**COUNCIL ACTION FORM**

**REQUEST: MAJOR SITE DEVELOPMENT PLAN FOR 2151 COTTONWOOD ROAD**

# Attachment B: Major Site Development Plan (Landscaping)

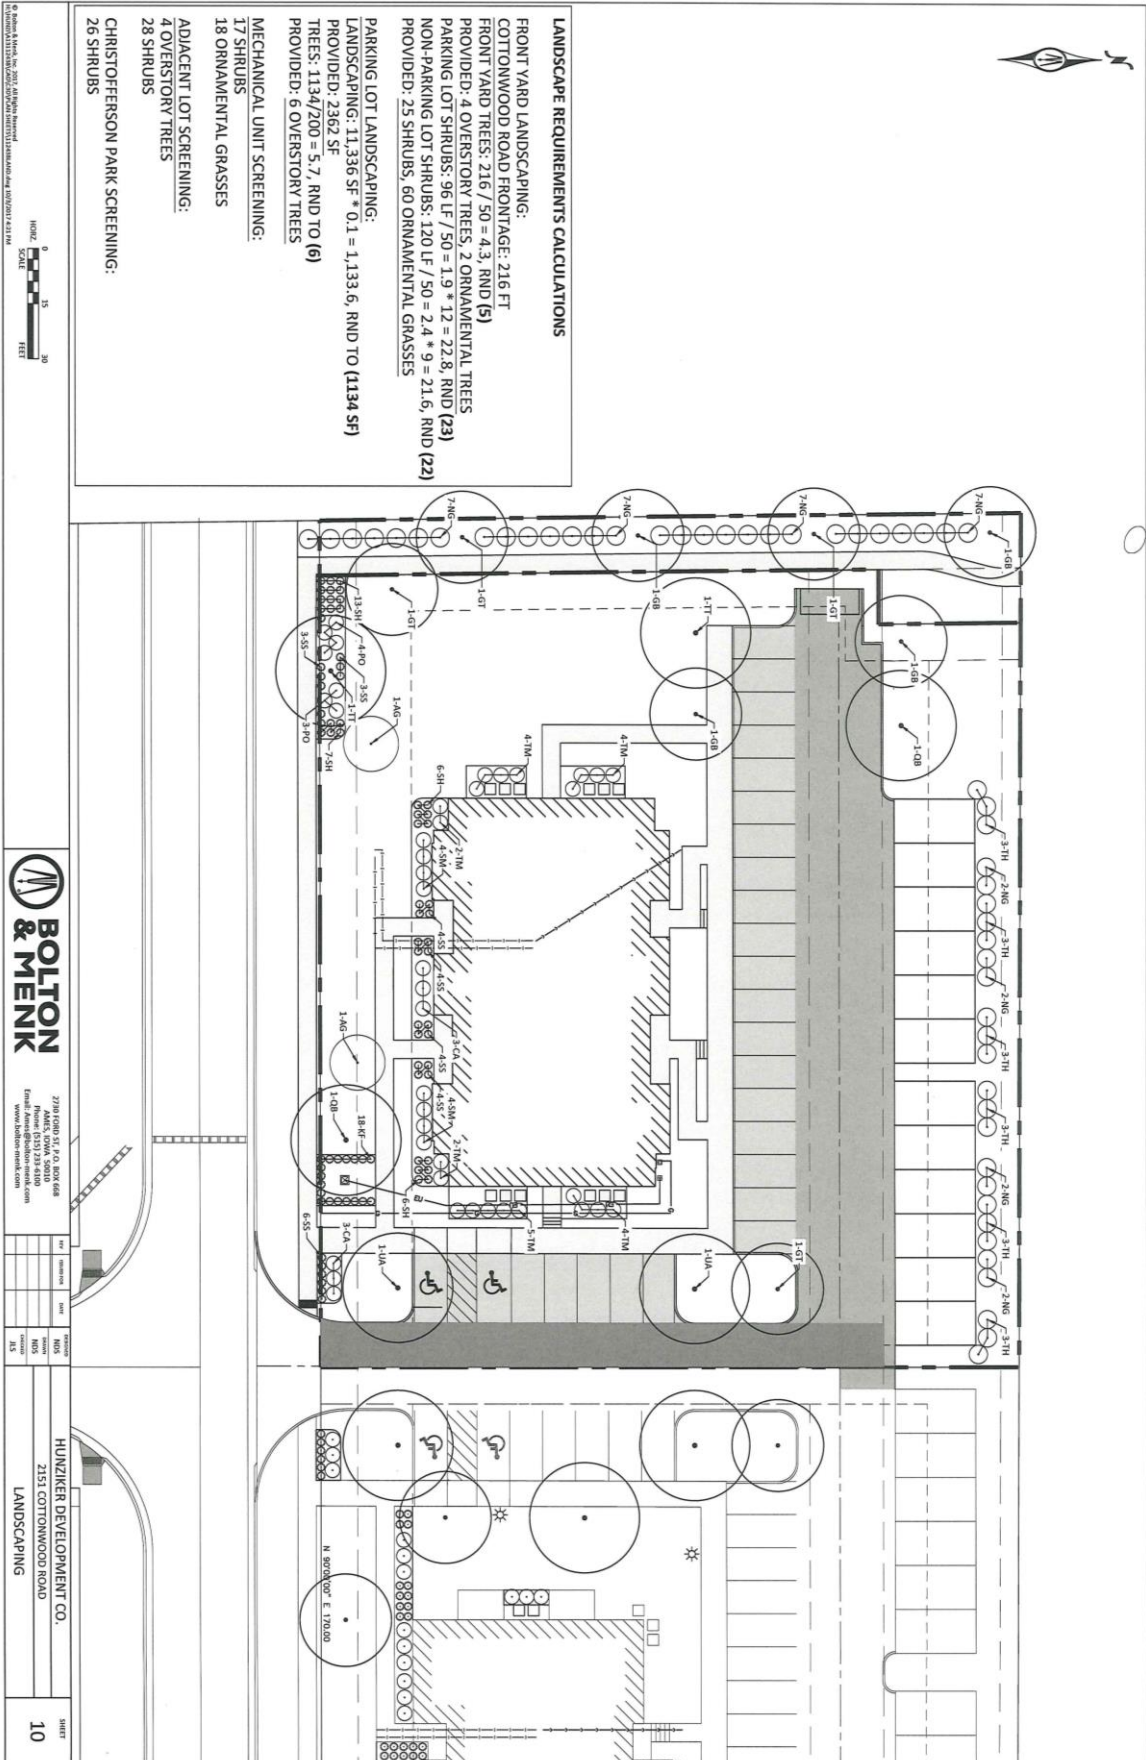
Landscaping requirements are derived from parking lot layout, front yard plantings, and transitional buffers. (See Page 20 of the report for the landscape plan). The proposed project's landscaping is predominately required for conformance to the front yard plantings, which are required by the recently adopted residential landscaping standards. The developer has chosen to propose front yard landscaping concentrated along the building façade rather than distributed throughout the site. Most of the parking areas are screened, with the developer relying upon distance from the street and intervening trees to act as the buffer to parking on the west side of the site. Unlike the properties located east of this site, and north of Cottonwood Road, the rear lot line does not abut the Wessex apartment development. The rear lot line for the property at 2151 Cottonwood abuts Christofferson Park. Screening was not required behind the garages for properties that abut the Wessex apartment development; however, the Planning and Zoning Commission and staff believe it is necessary that large shrubs be included as a buffer between the two 6-stall garage buildings and Christofferson Park to soften the appearance from the open space. The developer has added large shrubs on the back side of the two garage structures, as shown on the revised Landscaping Plan received following the Commission meeting on September 20. A formal high screen planting was not required along the north property line.

The west boundary of the site will interface with single-family homes in the future. The FS development standards require a high screen along such an interface. Staff has worked with the developer to place the high screen landscaping within the outlot and move the required walkway connection towards the apartment building. This provides greater visibility and safety along the walkway and meets the intent of a buffer of the use to future single family homes.

Perimeter parking lot landscaping that includes overstory trees is required along the portions of the driveways, parking spaces, and drive aisles to meet perimeter parking lot landscaping (See Attachment B: Major Site Development Plan, Landscaping- pg 20). Staff believes the project meets the intended parking lot dispersal requirements as proposed.

- B. Prior to occupancy, complete the High Screen plantings within Outlot B as a substitute for onsite plantings.
2. The City Council can approve the Major Site Development Plan for the proposed 12-unit apartment building, located at 2151 Cottonwood Road, with modifications.

# Attachment C: Building Elevations

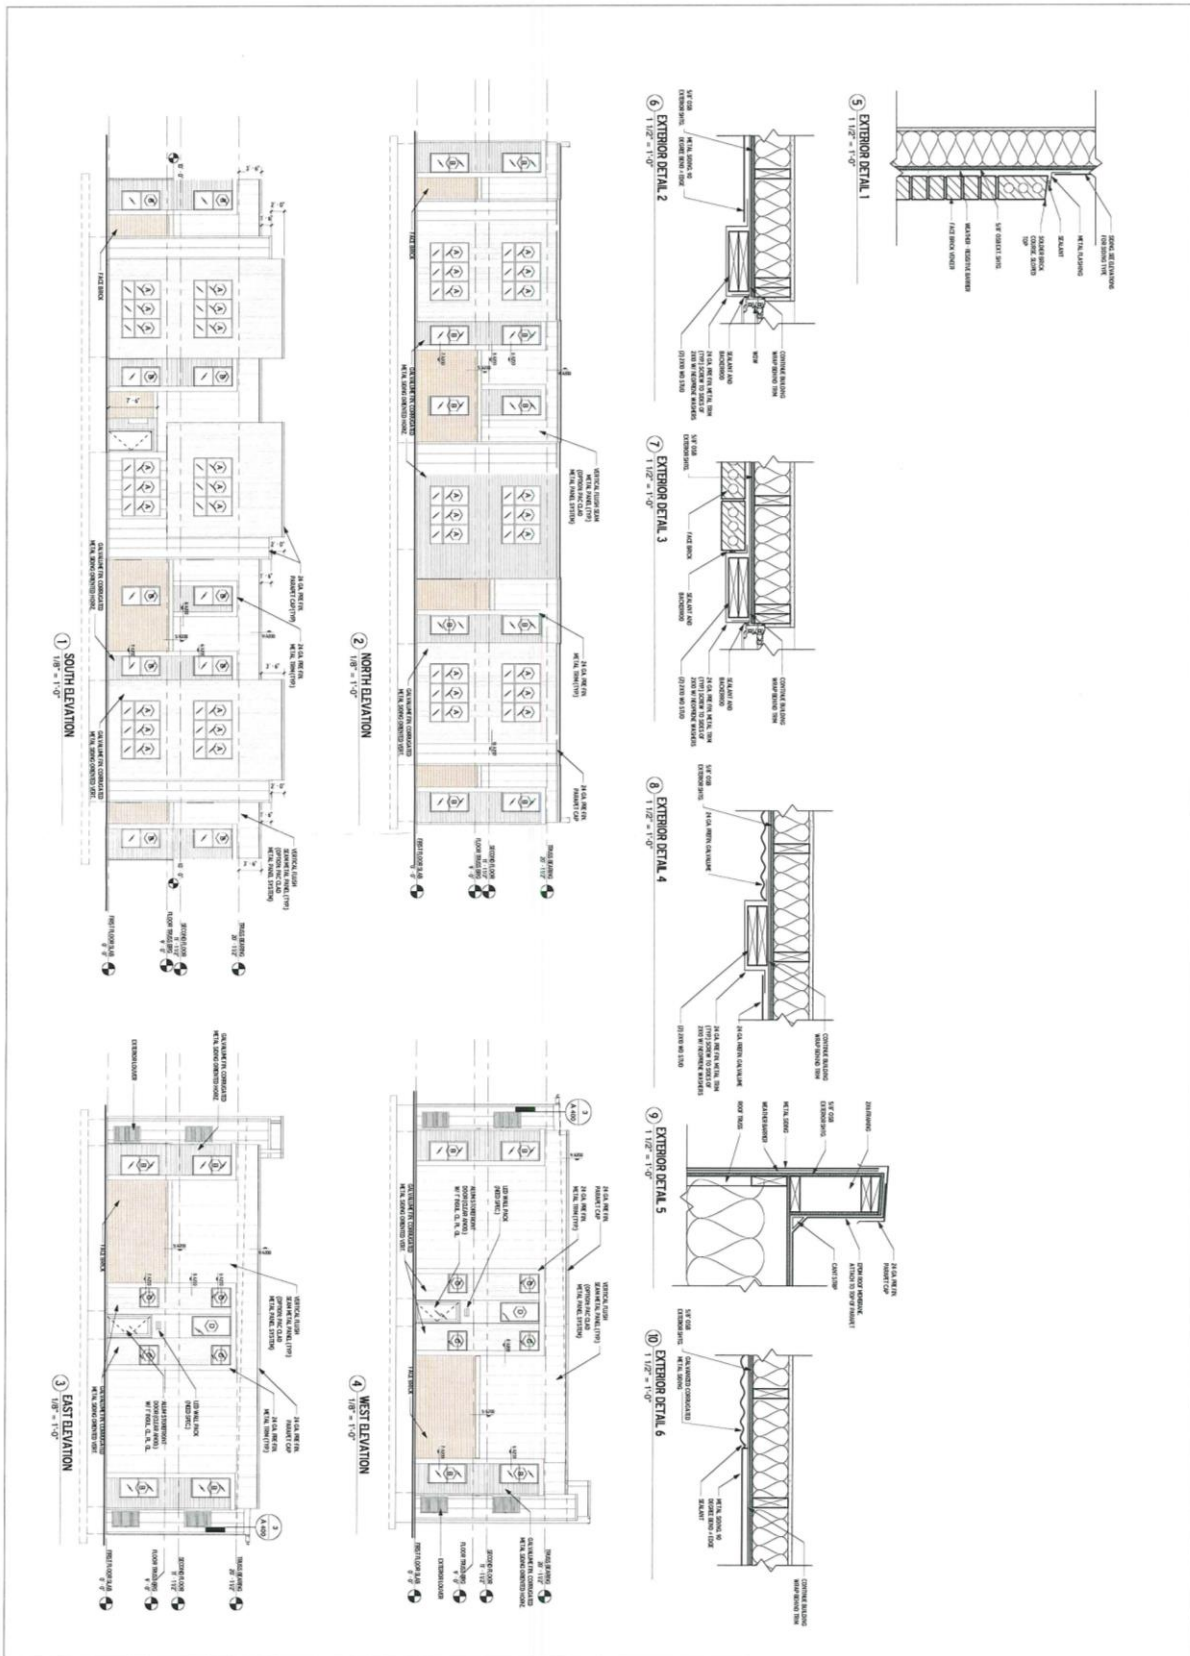
The design has a very modern style architectural appearance with the flat roof and parapets that are similar to some commercial building features. The parapets are intended to address architectural interest for the building. Staff believes the design creates some desirable architectural interest but the extended parapet heights also

create some disproportionately tall façade elements compared to the main area of the building. The proposed building design is a departure from the architectural design of the other 12-unit apartment buildings approved along the north side of Cottonwood Road, which are 3-story buildings with gabled roofs. Exterior building materials for the other buildings include vinyl lap siding with cultured stone veneers, and cultured stone pillars that support decks and roofs above the decks, as well as above the primary entry to each building. The developer also intends to propose two-story flat roof buildings of the same type as this application for remaining undeveloped lots located on Aurora.

The building design has a modern design style in terms of its massing and use of exterior materials and architectural features. The proposed materials are very contemporary with the metal siding, parapet on the south building elevation, and the flat roof. There are very few examples of this design approach in Ames outside of commercial areas, which makes it hard to visualize how successful the design will be compared to the other buildings in Village Park. Although staff has some concerns on individual features of the design, the modern style in this area of Village Park can be found compatible with the surroundings.

# Attachment F: Village Park Subdivision and Landscape Plan

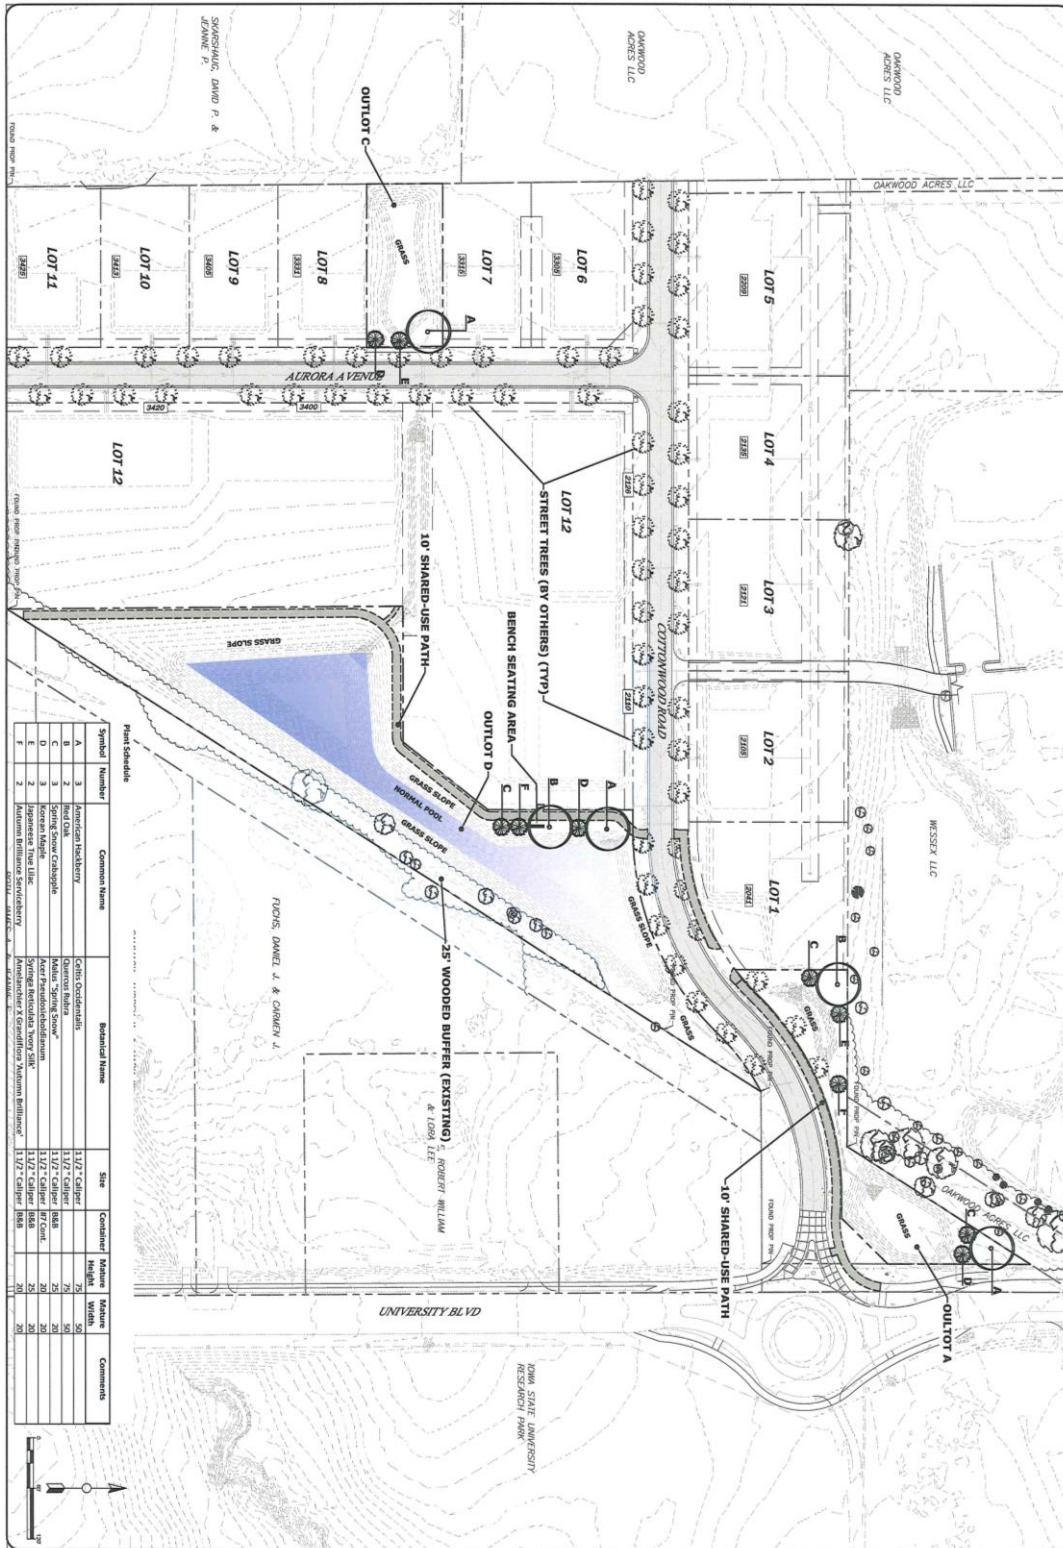
The FS-RM zone includes requirements for common open space equaling 10% of the overall FS-RM area in a development. The common open space that serves the tenants of the proposed apartment building, and all lots in the FS-RM portion of Village Park Subdivision, is located within outlots (*See Attachment F: Open Space Landscape Plan*). Notably, Outlot B abuts this site and provides a walkway connection from Cottonwood to the Christofferson Park boundary to the north. The other outlots in the subdivision are principally designed for stormwater treatment facilities.

Landscaping on Lot 5 is provided to meet the new residential landscaping standards for residential development. This includes new front yard landscaping requirements and for the parking lot. The site also triggers FS development standards for side and rear yard landscaping, notably for the west property line that will be a future interface with single family development. A high screen is required along the west property line to meet landscape buffer requirement in the FS-RM zone where the lot is adjacent to any lot zoned as FS-RL or RL. Staff has recommended that the developer propose an alternative landscape approach for the high screen and outlot along the west property line. The developer proposes provide the landscape buffer along the west 10 feet of Outlot B, abutting the west property line of this site and to construct the required walk along the east side of the outlot. City staff is supportive of locating the buffer in the Outlot to ensure the walkway is visible and not cutoff by landscaping. The property owner of Lot 5 would be responsible for the long term maintenance of the landscaping if it is not cared for as part of the common area as it is a substitution for onsite landscaping.
